MG Niche Flair Limited Ltd. (Unit-2)

H-240, Bhuyanpara, Siddirgonj, Narayangonj
(23.654738, 90.511708)

18th May 2017

Observations

**Column to be stressed above normal
design limits**

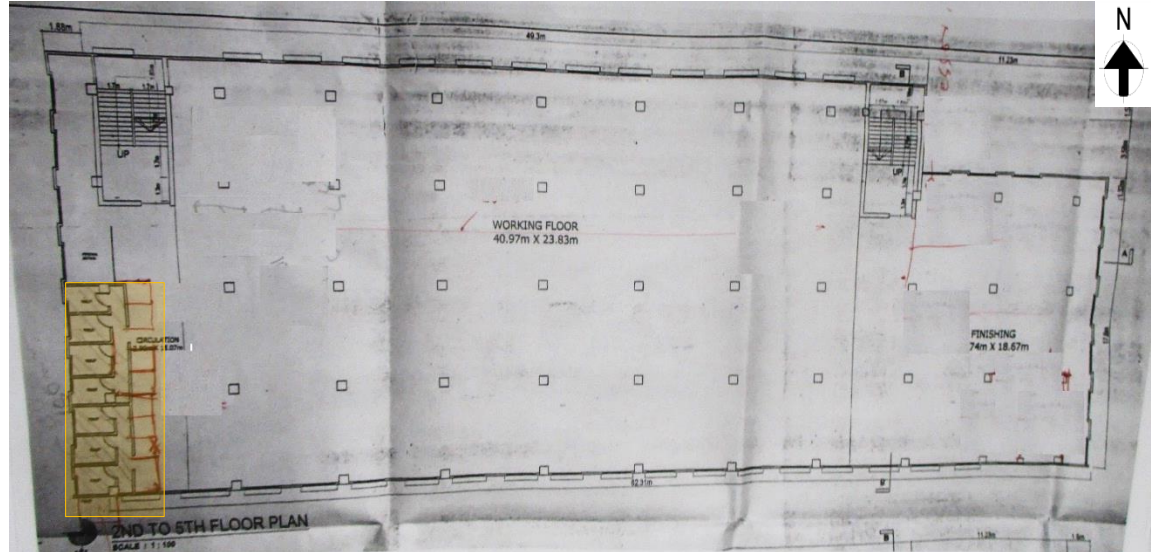
Cursory calculations indicate that the working stress of the column under toilet area would appear to be stressed in excess of normal design limits. Refer to Action 1. Building Engineer to verify in-situ concrete strength and confirm grade of steel reinforcement used.

Item No.	Observation	Recommended Action Plan	Recommended Timeline
1	(Production building) Column to be stressed above normal design limits	Factory Engineer to review design, loads and columns stresses in area identified above.	Immediate - Now
2	(Production building) Column to be stressed above normal design limits	Verify insitu concrete stresses either by 100mm dia. cores or existing cylinder strength data for [the identified columns] or [100mm dia. cores from 4 columns].	Immediate - Now
3	(Production building) Column to be stressed above normal design limits	A Detail Engineering Assessment of Factory to be commenced, see attached Scope.	Immediate - Now
4	(Production building) Column to be stressed above normal design limits	Produce and actively manage a loading plan for all floor plates within the factory giving consideration to floor capacity and column capacity.	6-weeks
5	(Production building) Column to be stressed above normal design limits	Detail Engineering Assessment to be completed	6-weeks

Absence of relevant technical documentations

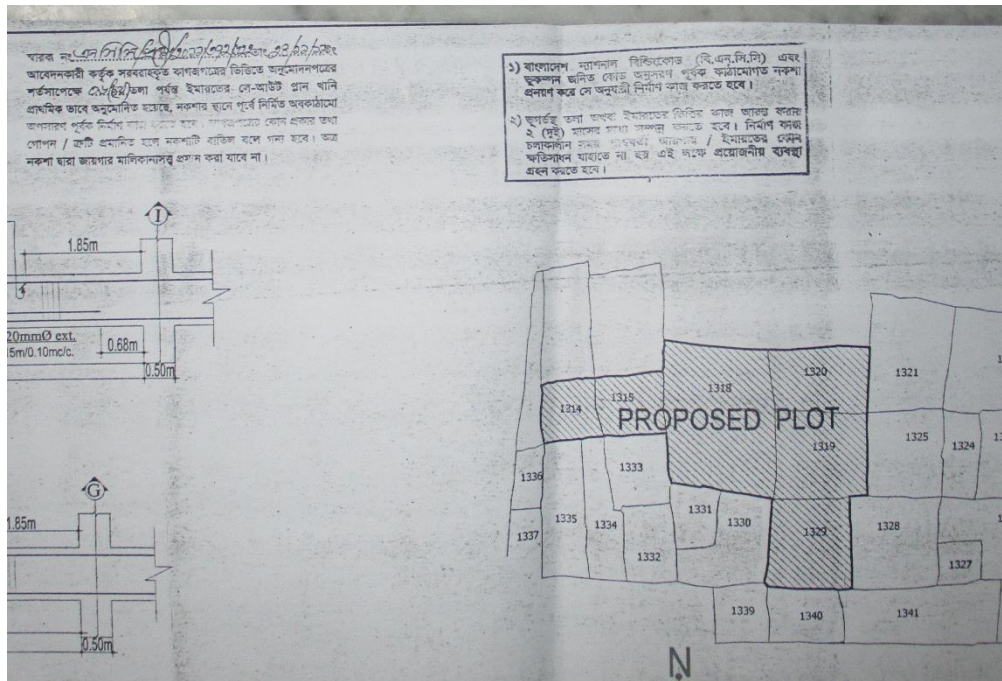
Cantilever slabs were observed on the all elevations of the building. Building Engineer to check structural adequacy of the cantilever and propose and implement any strengthening works if required.

Item No.	Observation	Recommended Action Plan	Recommended Timeline
8	(Production Building) Absence of relevant technical documentations	Building Engineer to confirm that the cantilever slabs have been designed to take the floor and façade loads applied, as part of DEA (See Item 1).	6-weeks
9	(Production Building) Absence of relevant technical documentations	Certified copy of the original design documents to be made and the existing As-built drawings to be updated accordingly.	6-weeks
10	(Production Building) Absence of relevant technical documentations	If changes are observed, Building Engineer to ensure a code adequacy of the constructed structure.	6-months
11	(Production Building) Absence of relevant technical documentations	Remedial works to be carried out if required.	6-months
12	Expose rebar at roof	All exposed reinforcement is required to protect from corrosion which may cause degradation of the concrete.	6-weeks
